**PROPOSED GREEN FUEL STATION (ELECTRIC VEHICLE CHARGING) AND SHOP AND  
SERVICES (CONVENIENCE STORE) AT WORKSHOPS 7 & 8 ON GROUND FLOOR,  
METRO CENTRE, 32 LAM HING STREET, KOWLOON BAY, KOWLOON**

**Planning Application No. A/K13/334 – Further Information (5)**

**Consolidated Report**

**Attachment 1: Response-to-Comment Table (Departmental Comments)**

1:250 in A4

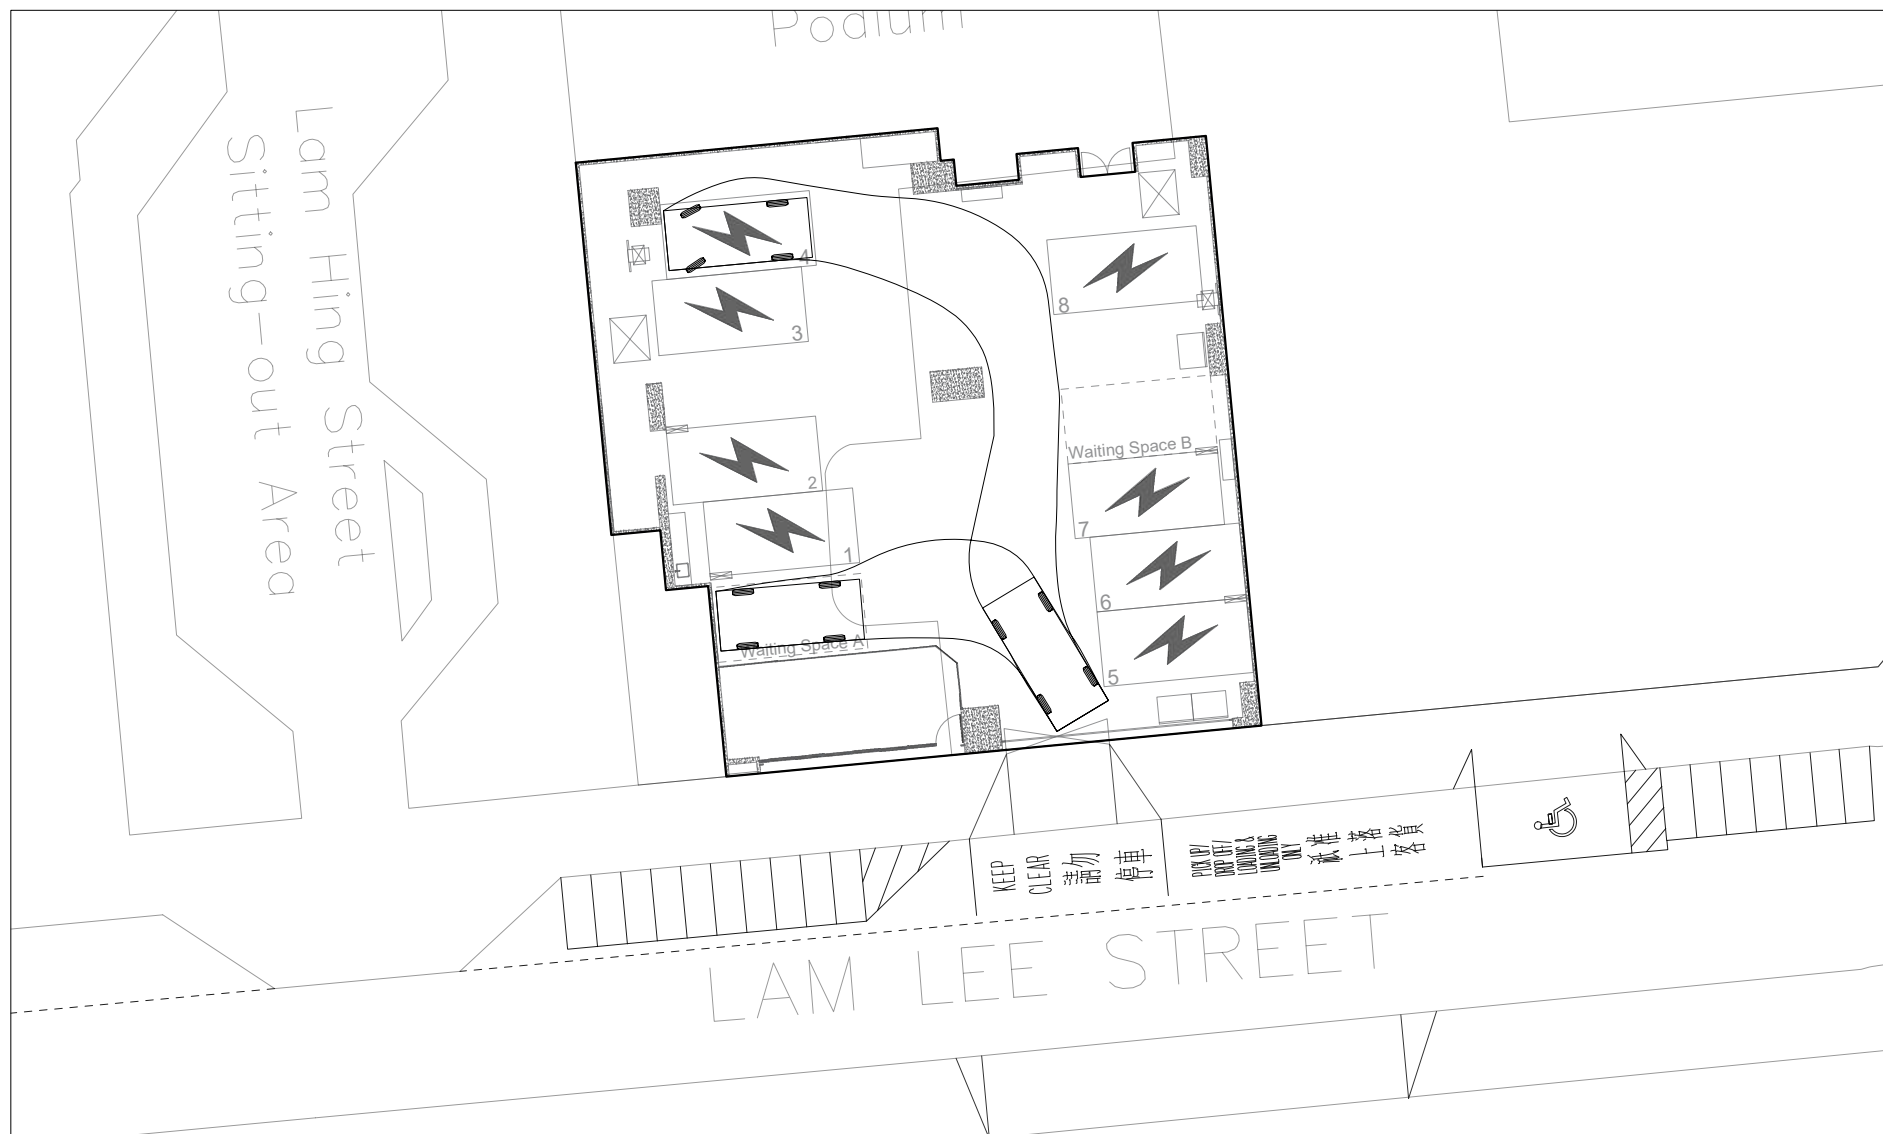
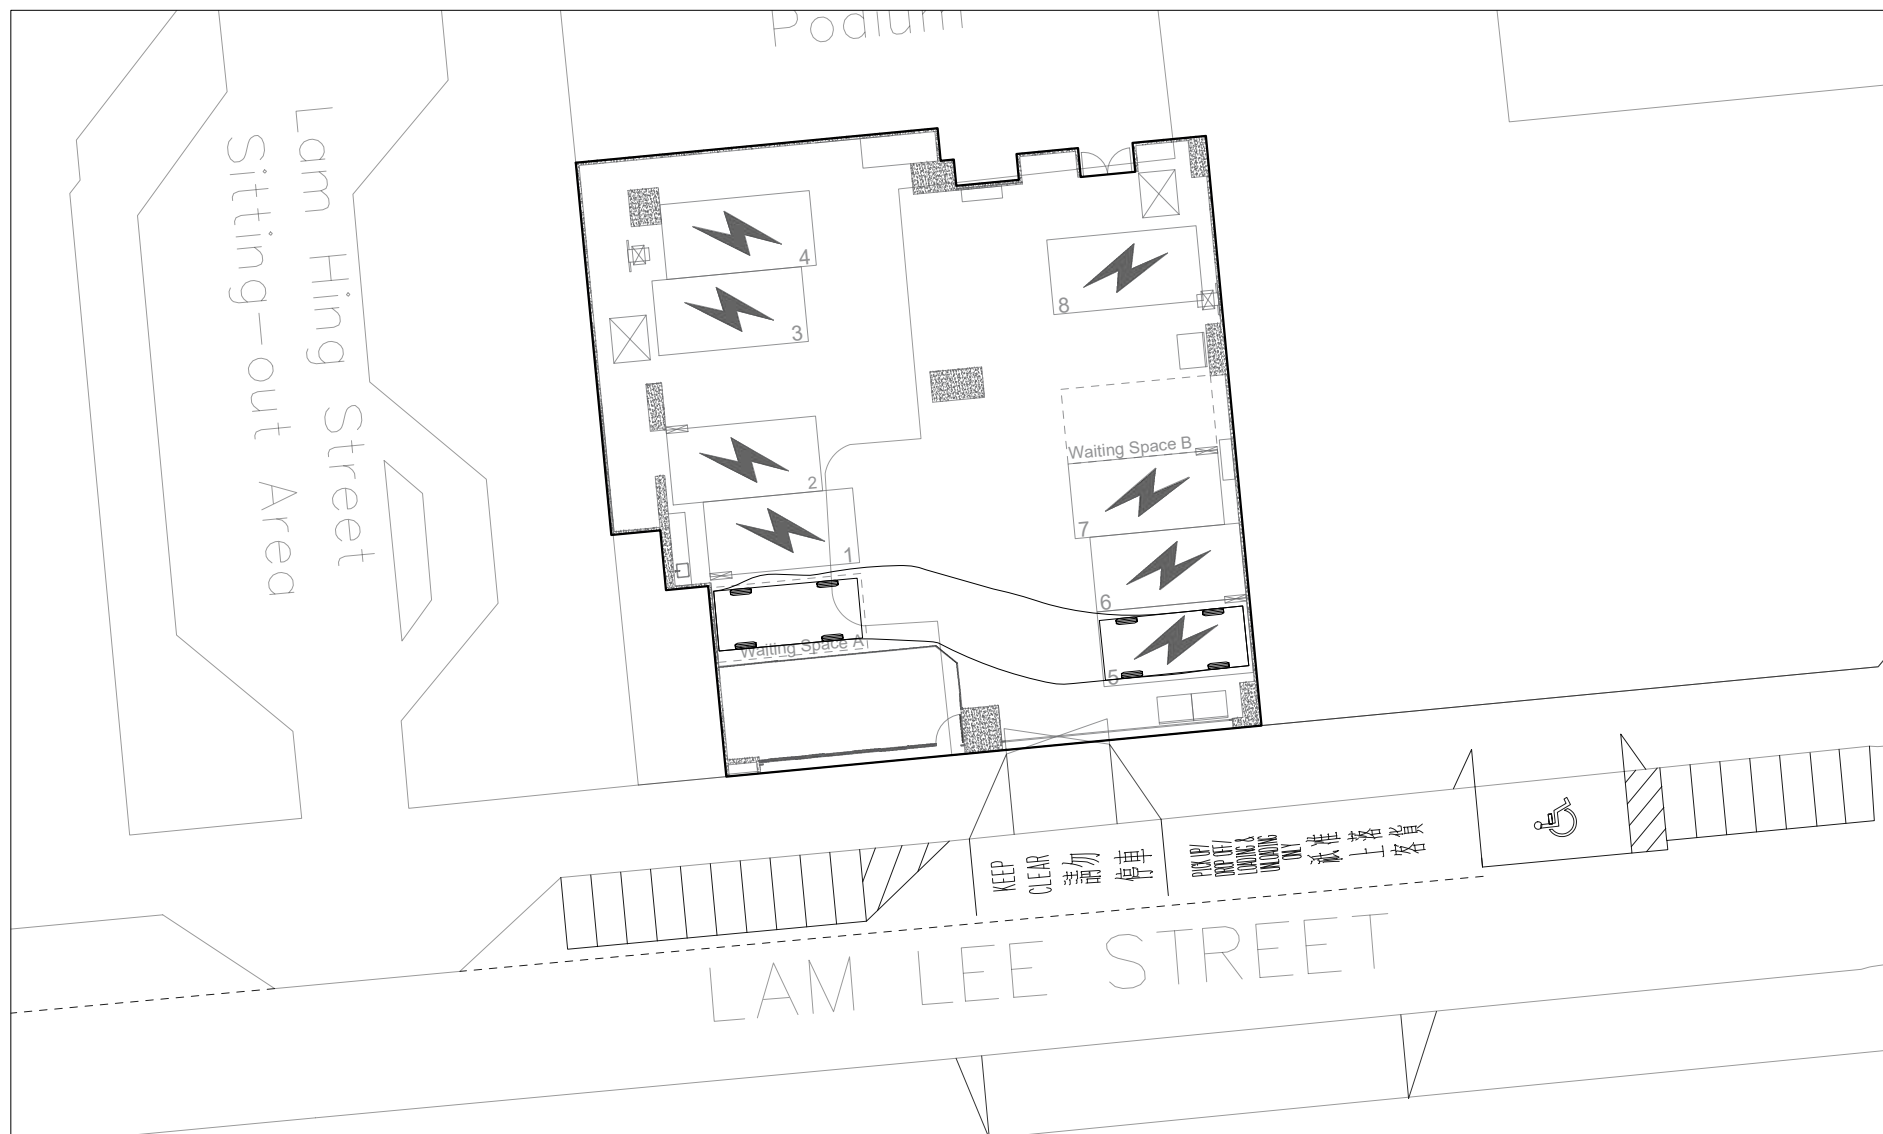
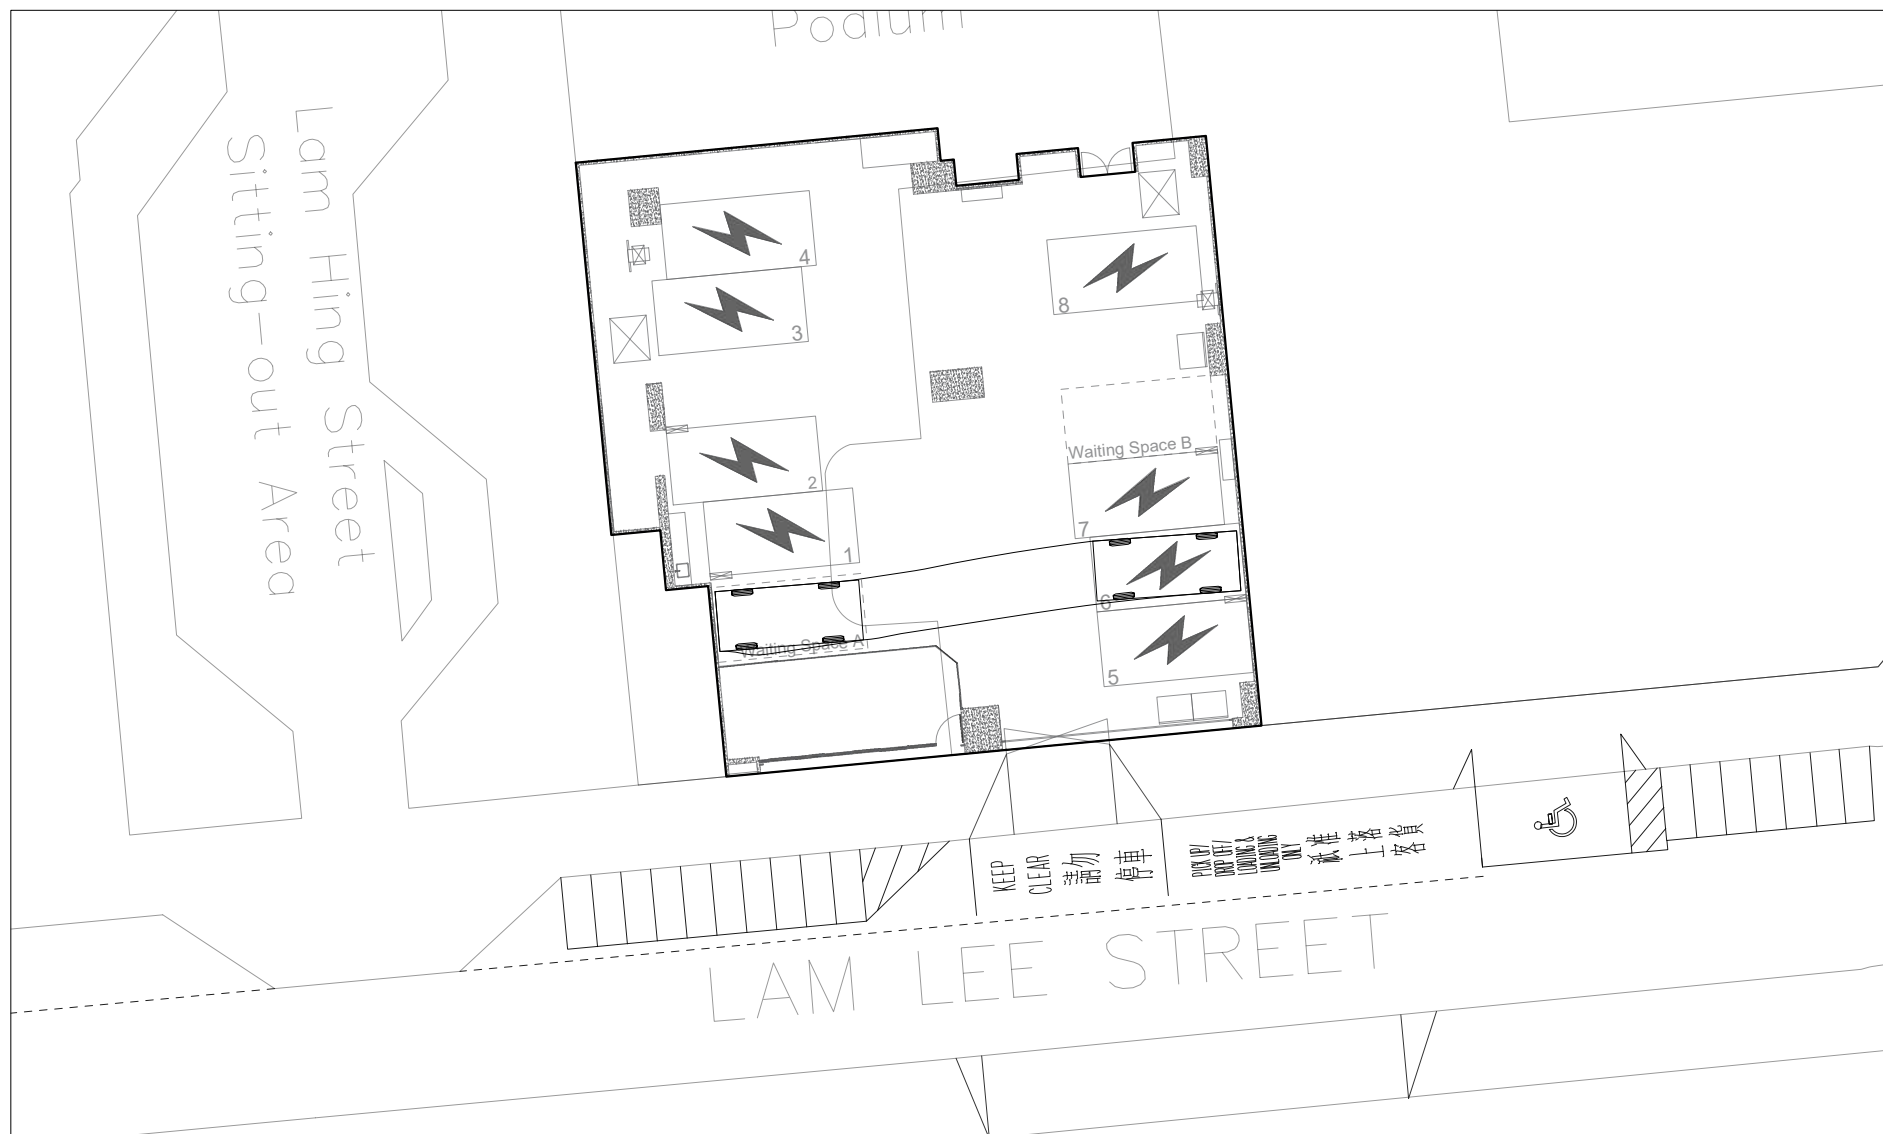
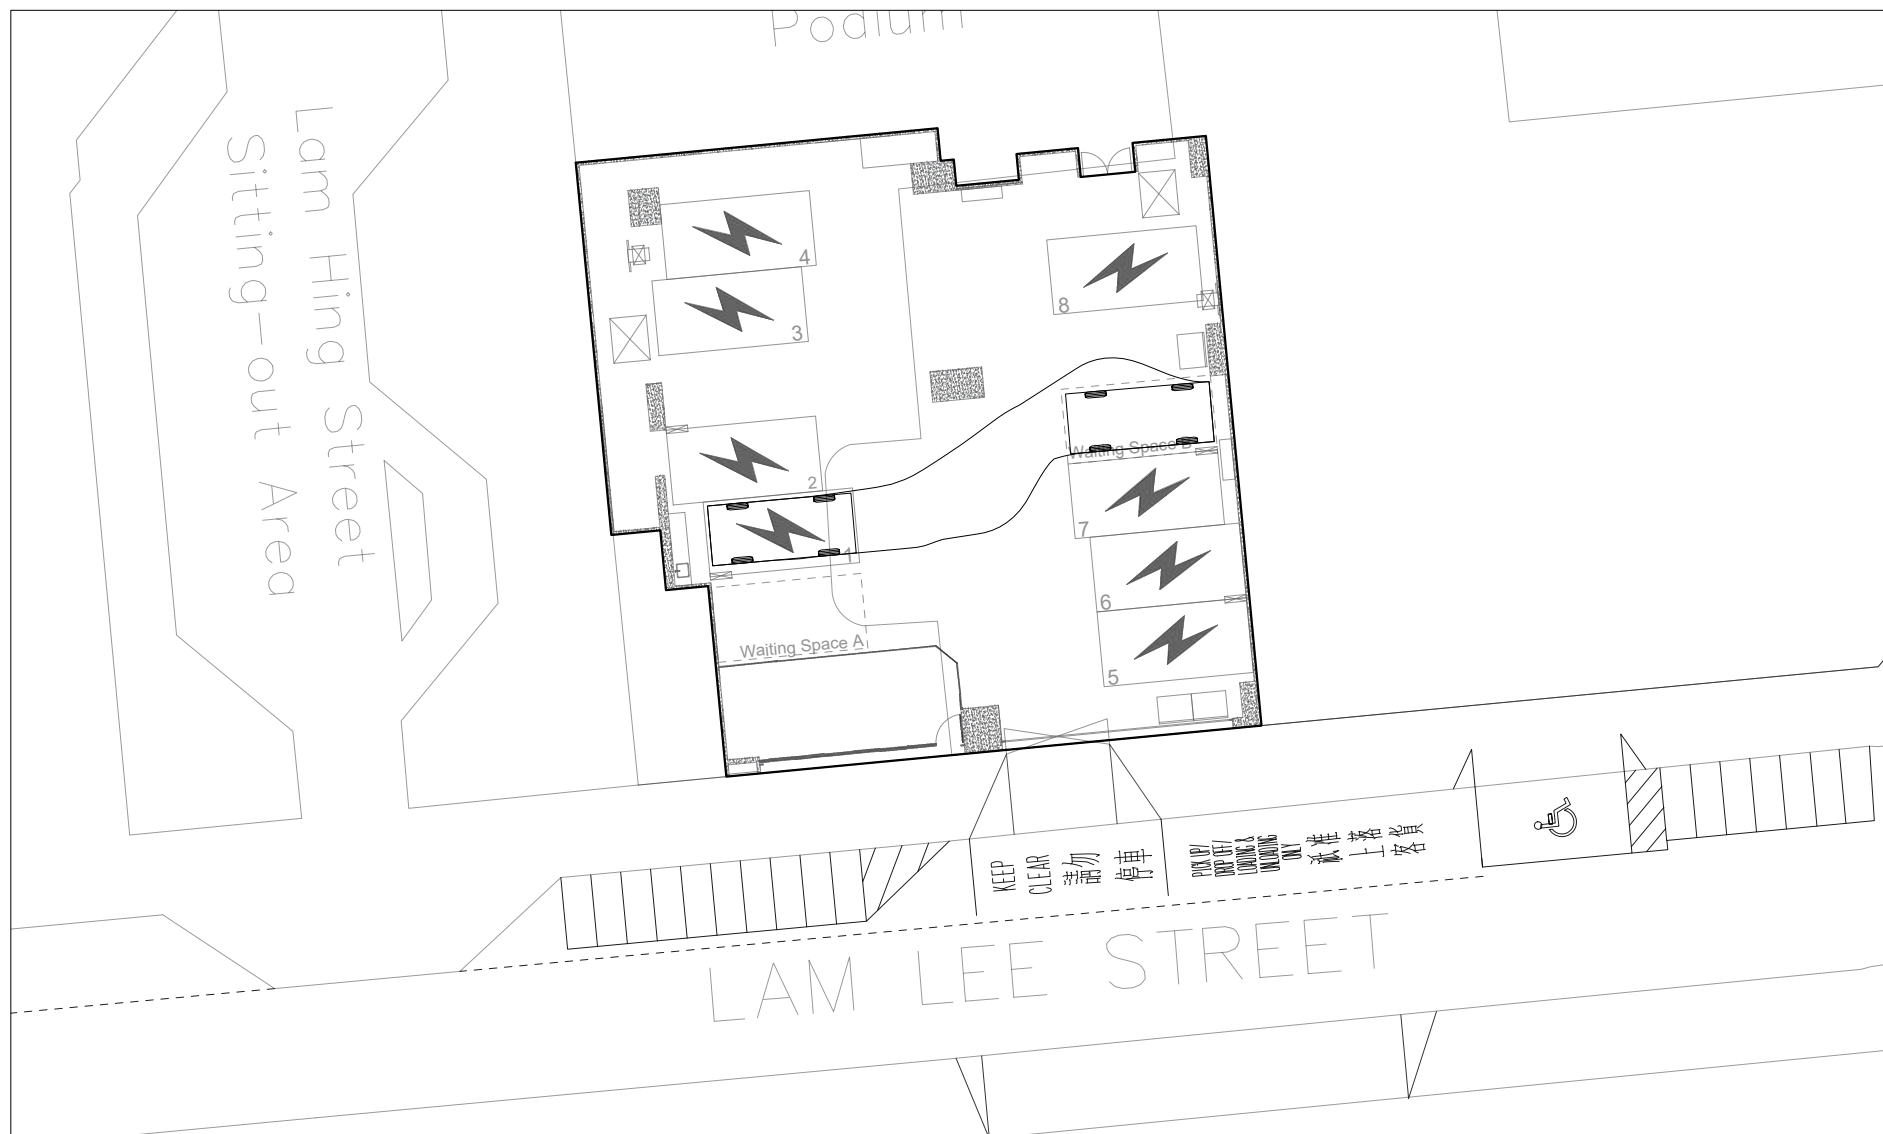
| <i>Departmental Comments</i>                                                                                                                                                                                                                                                                                                                                                                                                                                                                                                                                                                                                                                                                                                                                       | <i>Response</i>                                                                                                                                            |
|--------------------------------------------------------------------------------------------------------------------------------------------------------------------------------------------------------------------------------------------------------------------------------------------------------------------------------------------------------------------------------------------------------------------------------------------------------------------------------------------------------------------------------------------------------------------------------------------------------------------------------------------------------------------------------------------------------------------------------------------------------------------|------------------------------------------------------------------------------------------------------------------------------------------------------------|
| 1. The swept path analyses of the vehicle entering and leaving the EV charging spaces No. 1, 3, 6, 7 and 8 as well as the waiting spaces No. 1 and 2 are missing. Please provide those swept path analyses for further review.                                                                                                                                                                                                                                                                                                                                                                                                                                                                                                                                     | Please refer to <b>Appendix A of Attachment 2 – Revised Traffic Review Report</b> for the swept path analyses of all charging spaces and waiting spaces.   |
| 2. The backward movement of vehicles on the public road for entering the EV charging space No. 2 of the Premises was noted based on the swept path analyses as enclosed in Appendix A of the Traffic Review Report. We do not support it from traffic engineering perspective, which such backward movement of vehicles on the public road for entering the Premises may pose potential danger and raise road safety issues to the road users. Please review and revise the swept path analyses, and also                                                                                                                                                                                                                                                          | Noted. Please refer to <b>Figure 3 in Appendix A of Attachment 2 (p.25)</b> , showing the revised swept path of the vehicle entering charging space No. 2. |

| <i>Departmental Comments</i>                                                                                                                                                                                                                                                                                                                                                                                                                                                                                                                                                                                                                                                                                                                                                                                                                                                                                                                                                                                                                                                        | <i>Response</i>                                                                                                                                               |
|-------------------------------------------------------------------------------------------------------------------------------------------------------------------------------------------------------------------------------------------------------------------------------------------------------------------------------------------------------------------------------------------------------------------------------------------------------------------------------------------------------------------------------------------------------------------------------------------------------------------------------------------------------------------------------------------------------------------------------------------------------------------------------------------------------------------------------------------------------------------------------------------------------------------------------------------------------------------------------------------------------------------------------------------------------------------------------------|---------------------------------------------------------------------------------------------------------------------------------------------------------------|
| 2. As referring to the swept path analyses in the revised traffic review report, it is noted that reverse movement of the private car from the public road to the captioned EV charging station would not be required. However, it only shows the swept path of the private car from the waiting space A to the charging space no. 8 as well as the swept path of the private car from the waiting space B to the charging space no. 1. Please supplement the swept path analyses of the private car from the waiting space A to all the other charging spaces. Similarly, please supplement the swept path analyses of the private car from the waiting space B to all the other charging spaces. Please be noted that the drivers would wait at the waiting spaces once all the charging spaces in the EV charging station are full. Once the charging space is available, the driver at the waiting space should be able to access the vacant charging space (i.e. can be any of the charging space no. 1 to 8) without requiring to have reverse movement onto the public road. | Noted. Please refer to the revised swept path analyses in <b>Attachment 2</b> for your reference.                                                             |
